Lower Thames Crossing

9.152 Responses to the Examining Authority's ExQ2 Appendix F – 10. Road Drainage, Water Environment & Flooding

Planning Inspectorate Scheme Ref: TR010032
Examination Document Ref: TR010032/EXAM/9.152

Plate 1 Extract from the Works Plans Sheet 6 – Utilities [REP4-040] showing SS4 and SS5

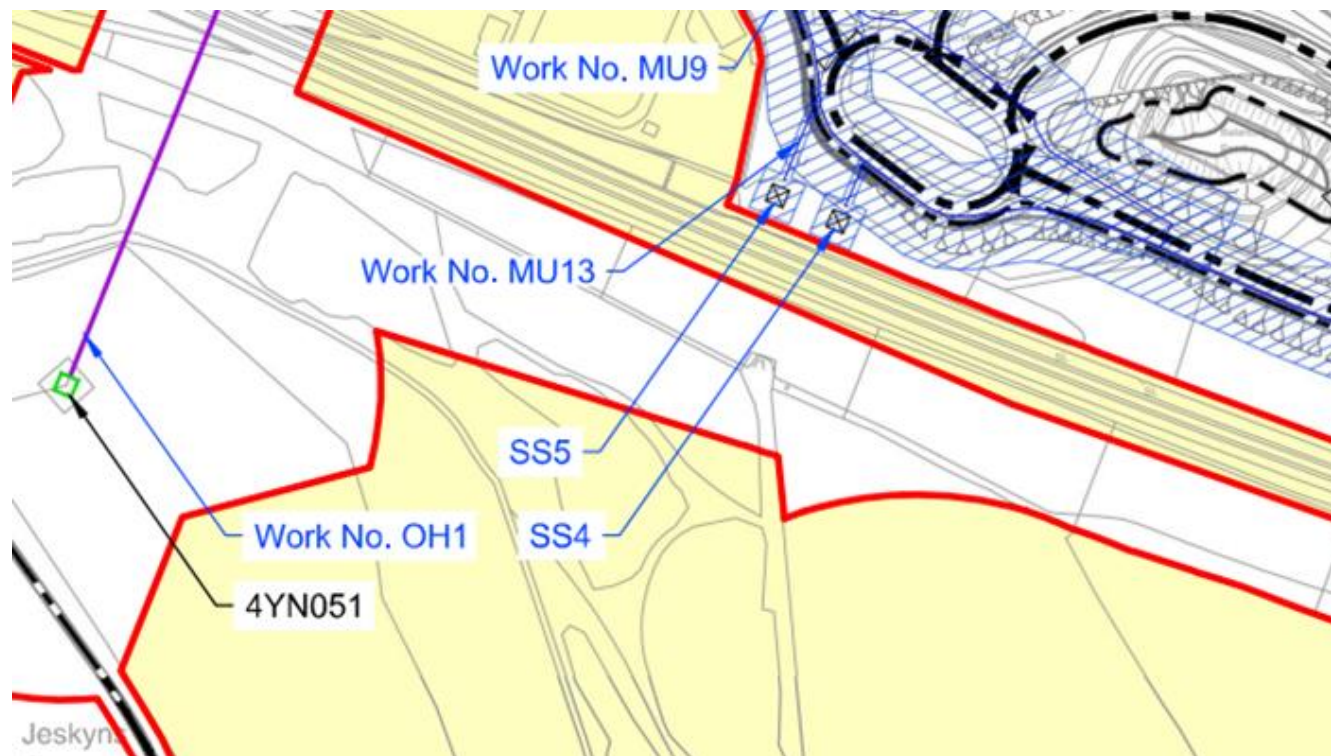
PINS ID	Question to	Question / Response
ExQ2_Q10.1 .1	Applicant only	<p>Surface water flood risk</p> <p>The Applicant's response to ExQ1 Q10.2.1 is noted, particularly the point that " mitigation measures will be developed during detailed design in conjunction with the highway drainage design": however Gravesham Borough Council, in their submission [REP4-291], suggests that there are significant issues to be dealt with at detailed design stage, particularly, as the Council notes, "...the Works Plan shows two new sub-stations to be built south of the Cobham roundabout in this location (Works Plan REP2-037 shown as SS4 + SS5 and Work MU13 in the dDCO REP3-077) which appear to conflict with the position of the existing drainage culvert under HS1 ...". The Council suggests that the consequences could include a reduction in landscaping area opening the view from the south. This could also have biodiversity and flood risk consequences.</p> <p>Using the above as an example, can the Applicant provide sufficient detail to allow confidence that the conflict issue could be satisfactorily resolved at the detailed design stage, without compromising the design parameters, and within existing Order Limits? An outline design solution will suffice.</p> <p>Response:</p> <p>The Applicant is satisfied that the provisions and commitments contained within the Development Consent Order (DCO) application are robust and appropriate to ensure that at the detailed design stage the position of the two substations (SS4 and SS5) would not conflict with the existing High Speed 1 (HS1) drainage culvert, nor give rise to any biodiversity or flood risk.</p> <p>This shall be achieved via the following:</p> <ul style="list-style-type: none"> • The detailed design of the works will accommodate HS1 infrastructure as per Item 2.1.15 of the Statement of Common Ground between HS1 and the Applicant [REP4-108]. This is secured via the Protective Provisions contained within Schedule 14, Part 4 of the draft DCO [REP5-024]. • The selection and construction of a UK Power Networks standard substation designed specifically for its proximity to a watercourse. • By adhering to the commitments regarding the inspection and maintenance of drainage infrastructure contained within the Register of Environmental Actions and Commitments (REAC) items RDWE012 and RDWE014 [REP5-048]. • Via the locating of the proposed substations near the boundary fence of HS1 to reduce any potential biodiversity effects in relation to the forming of a barrier for wildlife movements.

PINS ID	Question to	Question / Response
		<p>The Applicant does not believe that the substation locations would give rise to a reduction in landscaping areas resulting in an opening of the view from the south for the following reasons:</p> <ul style="list-style-type: none"> • The proposed location is against an existing railway embankment over 6m in height, which affords a natural reduction in view of the 2.4m high substations from the south. • Furthermore, the designed highway level and the existing railway level have an approximate 6m difference in elevation, with the highway being the lower of the two features. The Applicant believes with standard design details adhered to, the substation roof would still be approximately 3m below the railway, screening it from views from the south. • The existing site is vegetated, providing a screen of views from the south. REAC LV001 [REP5-048] and Design Principle LSP.01 [REP4-146] commit to the retention of existing vegetation as far as reasonably practicable in order to 'preserve its function as a natural screen to the works'. • To ensure those views were not opened resulting in a detrimental effect, the detailed design would adhere to Design Principle STR.17 [REP4-146] and would 'Integrate any above-ground infrastructure required for the operation and maintenance of the utility networks into the setting of the area, or screen by landscaping, where practicable and compliant with the requirements of the utility owner.' <p>Further details regarding the two proposed substations (SS4 and SS5) are provided below to support this response.</p> <p>The two substations form part of the electricity distribution network and are to be consented as part of Work No MU13: 'Work No. MU13 comprises the diversion of multi-utilities, to include installation or diversion of underground utilities within a multi-utility corridor and the provision of two new substations (annotated as SS4 and SS5) in a 5m x 5m plot south of the new Cobham roundabout (Work No. 2U)' (Schedule 1 of the draft DCO [REP5-024]).</p> <p>The two substations are afforded a limit of deviation, as per article 6 of the draft DCO [REP5-024], to be located within the hatched area shown on sheet 6 of the Works Plans [REP4-040], of which an extract is included in Plate 1 below.</p>
